# Access Compliance Report

## Public Rights-of-Way

Intersection ID: 49136	Main Street: AMBER_LEIGH_WAY_DR	Cross Street: POPE_FARM_RD	Location: W
ADA ID: A42A2F1D3693	Ramp Type: Perp	Initial Pass/Fail: Fail	Overall Compliance: No
Severity Score: 22.5			
Codes/Mitigation Info/Possible Solution		Field Measurements/Component Compliance

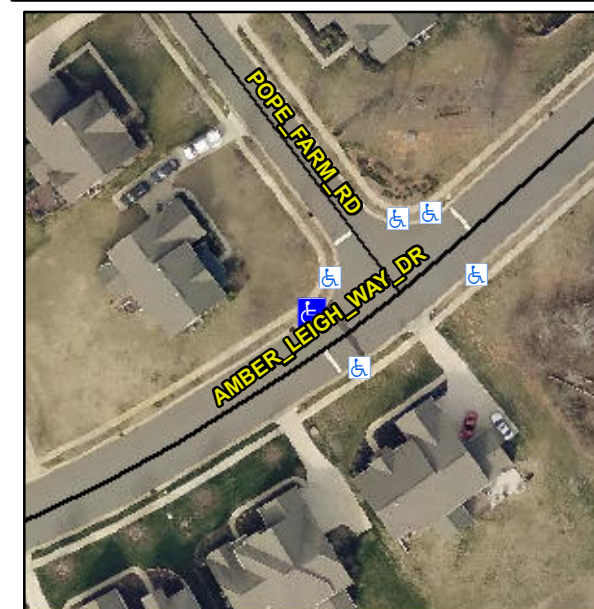
**R304.5.1, R304.2.2, R304.5.3**

Compliance	Description	Data	Compliance	Description	Data
N/A	Ramp Length (in)	48.0	No	Ramp Slope (%)	10.4
No	Ramp Width (in)	47.5	No	Ramp XSlope (%)	2.1
N/A	Flare Type LT	N/A	N/A	Flare Type RT	N/A
N/A	Flare Slope LT (%)	N/A	N/A	Flare Slope RT (%)	N/A
N/A	Flare Traversable LT?	N/A	N/A	Flare Traversable RT?	N/A
N/A	Landing Length (in)	N/A	N/A	DWS Provided?	N/A
N/A	Landing Width (in)	N/A	N/A	DWS Contrast?	N/A
N/A	Landing Slope (%)	N/A	N/A	DWS Length (in)	N/A
N/A	Landing X Slope (%)	N/A	N/A	DWS Full Width?	N/A
N/A	Landing Curb? (Y/N)	N/A	N/A	DWS Offset (in)	N/A
N/A	Shared Landing?	N/A			
N/A	Gutter Ponding?	N/A	N/A	Gutter Slope (%)	N/A
N/A	Gutter Lip Ht (in)	N/A	N/A	Gutter X Slope (%)	N/A
N/A	Painted X Walk1?	No	N/A	Painted X Walk2?	N/A
	X Walk 1 Direction	To SE		X Walk 2 Direction	N/A
N/A	X Walk 1 Width (in)	N/A	N/A	X Walk 2 Width (in)	N/A
	X Walk 1 Slope (%)	2.8		X Walk 2 Slope (%)	N/A
	X Walk 1 X Slope (%)	1.1		X Walk 2 X Slope (%)	N/A

**Remove & Replace Entire Ramp.**
